# UNITED STATES PATENT AND TRADEMARK OFFICE

APPLICATION NO.	FILING DATE	FIRST NAMED INVENTOR	ATTORNEY DOCKET NO.	CONFIRMATION NO.
10/720,767	11/24/2003	Jack A. Smith	090936.0529	4914

<b>Office Action Summary</b>	<b>Application No.</b> 10/720,767	<b>Applicant(s)</b> SMITH ET AL.	
	<b>Examiner</b> Vikansha S. Dwivedi	<b>Art Unit</b> 3746

### DETAILED ACTION

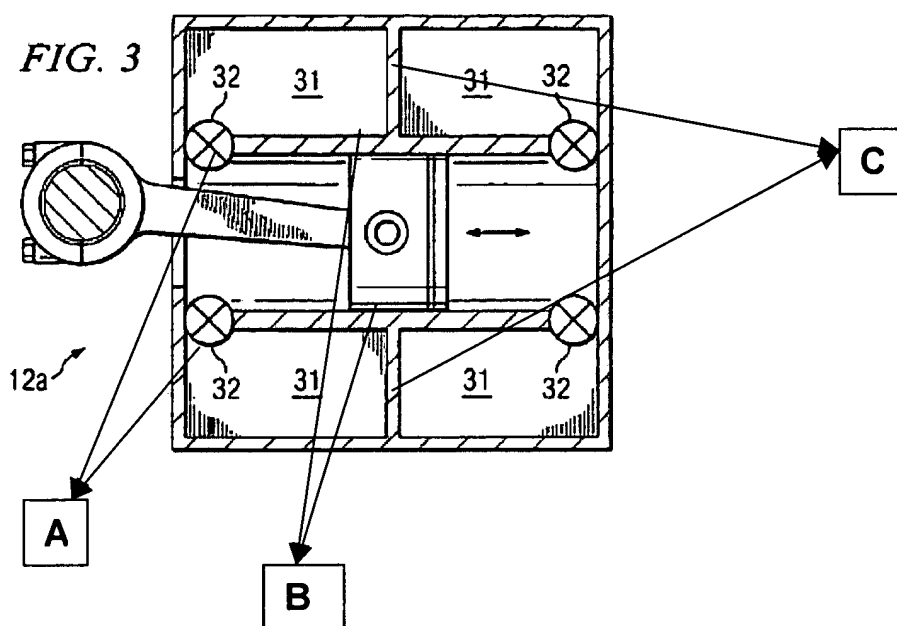
For the purpose of examination examiner is considering numeral 31 to define load pockets as shown in figure 3. It is not clear from the disclosure how the load pockets (31) change the compression ratio of the compressor. Further the use of the term discrete load is ambiguous.

The drawings are objected to because it is not clear how are valves (32) closer to the cam (As seen in figure 3 towards the left hand side) affect the unloading. It seems from the drawing that only two valves (32) that are located on the extreme right will facilitate unloading the compressor, it seems that if the set of valve A as indicated below will be useful in unloading if they were located at position B or C.

Since the drawings do not illustrate the valves in a manner that would create a properly unloaded compressor (for the left load pockets 31), one of ordinary skill in the art is not properly taught how to make and use the claimed invention.

Applicant is suggested to either provide an explanation for the current position of the valves and how they affect the unloading or provide corrected drawing. Corrected drawing sheets in compliance with 37 CFR 1.121(d) are required in reply to the Office action to avoid abandonment of the application. Any amended replacement drawing sheet should include all of the figures appearing on the immediate prior version of the sheet, even if only one figure is being amended. The figure or figure number of an amended drawing should not be labeled as "amended." If a drawing figure is to be
